Building Code of Australia

2019

Amendment 1

Summary and Instructions

Figure 3.5.1.5 Anti-capillary breaks

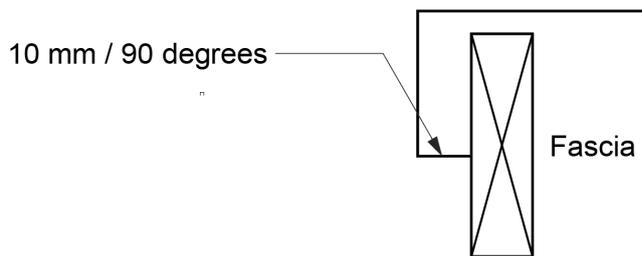
Delete Figure 3.5.1.5(b) and insert Figure 3.5.1.5(b) as follows:

(b) Fascia flashing

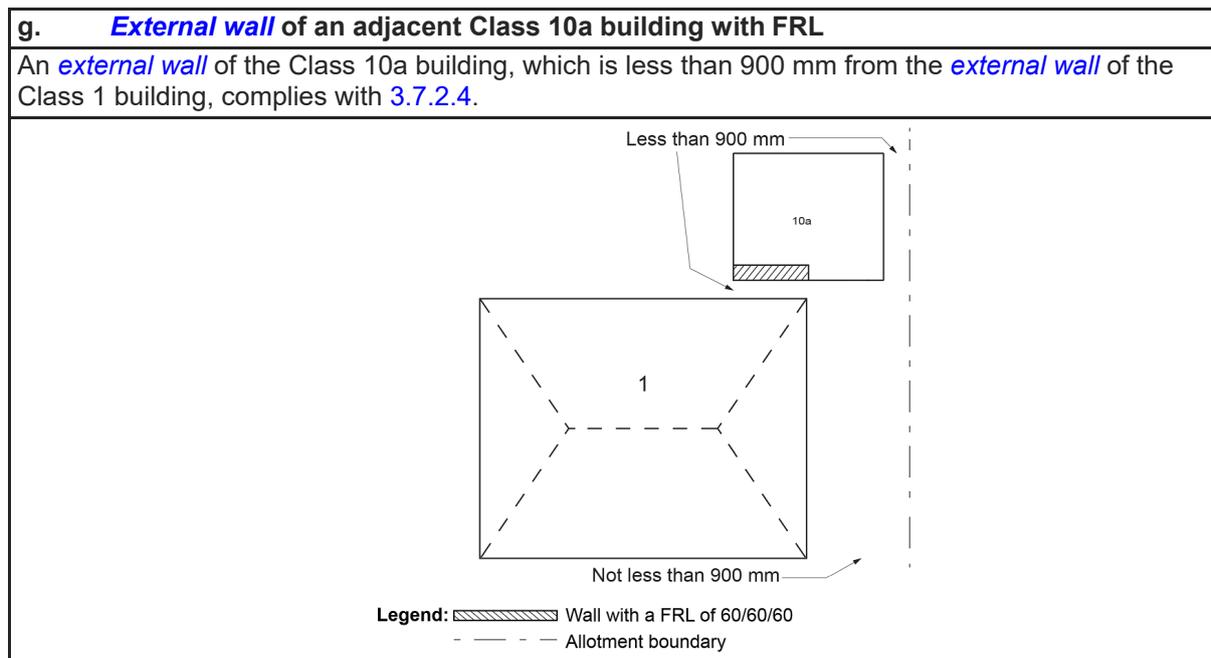
Delete Figure 3.7.2.4g of Part 3.7.2 and insert Figure 3.7.2.4g as follows:

h. Class 1 building with FRL to external wall

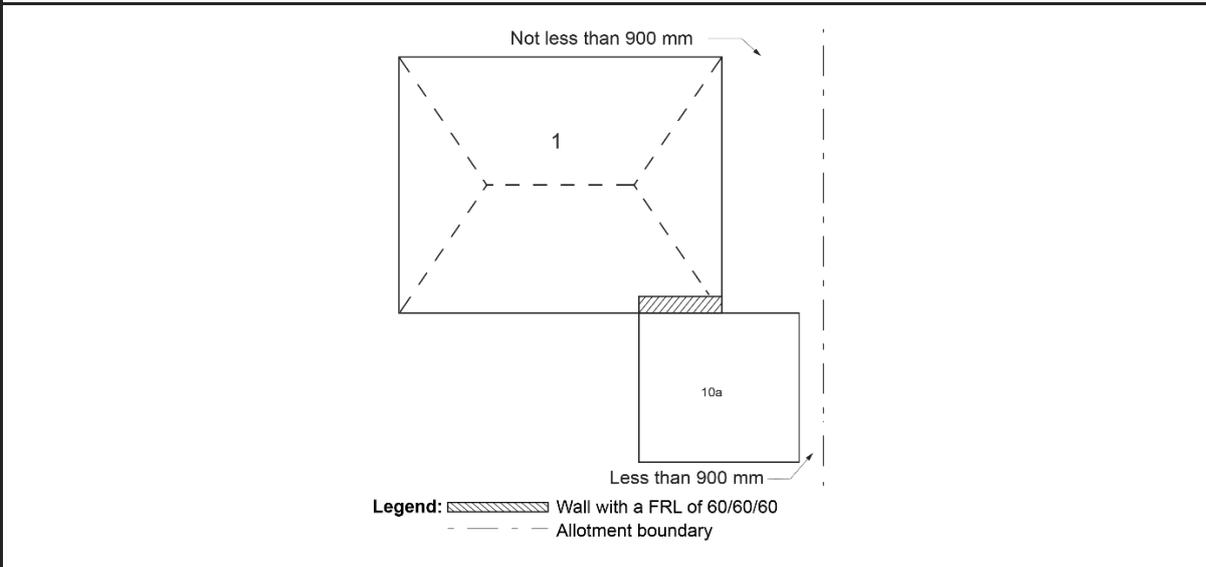
Delete Figure 3.7.2.4h and insert Figure 3.7.2.4h as follows:

An *external wall* of the Class 1 building, which is less than 900 mm from a Class 10a building that is situated less than 900 mm from an allotment boundary, complies with 3.7.2.4.

i. External wall to Class 10a building with FRL

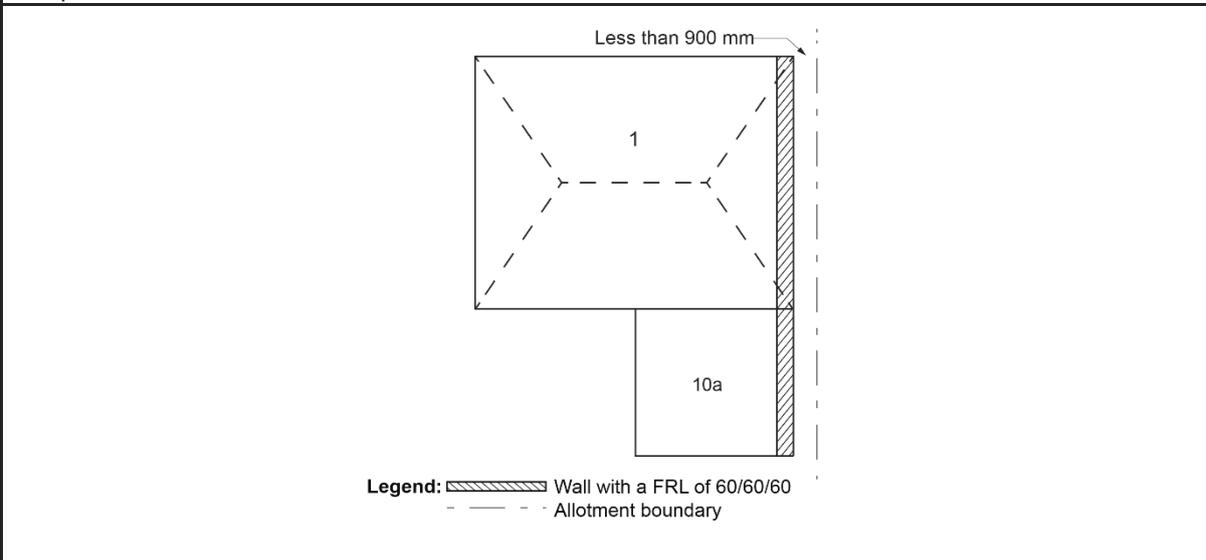
Delete Figure 3.7.2.4i and insert Figure 3.7.2.4i as follows:

The *external wall* of the Class 1 and Class 10a building which are less than 900 mm from an allotment boundary, other than the boundary adjoining a road alignment or other public space, complies with 3.7.2.4.

Figure 3.10.7.3 Typical installation of fireplace flue inserts

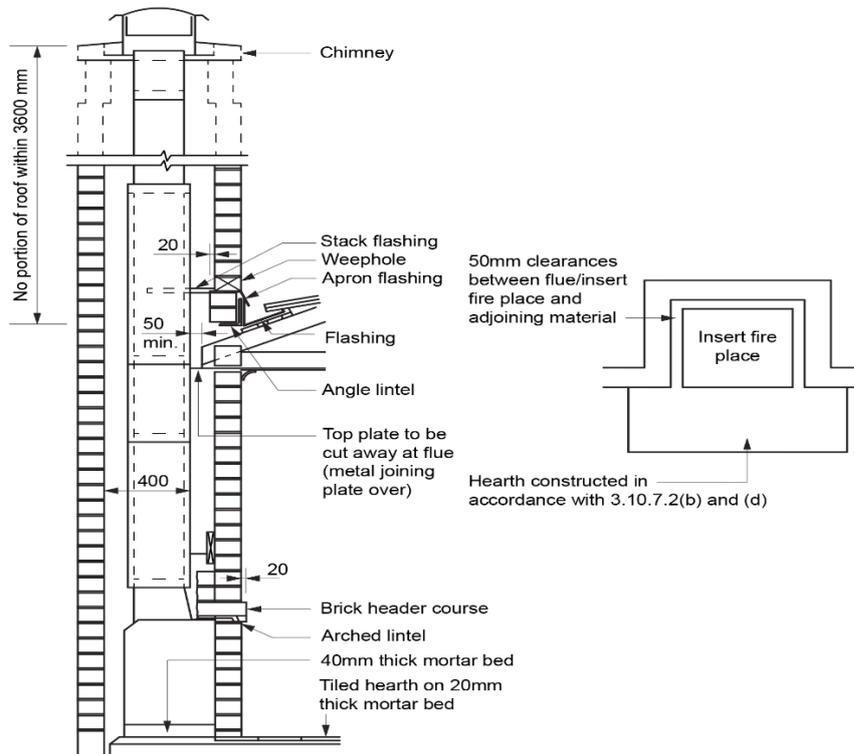
Delete Figure 3.10.7.3 and insert Figure 3.10.7.3 as follows:
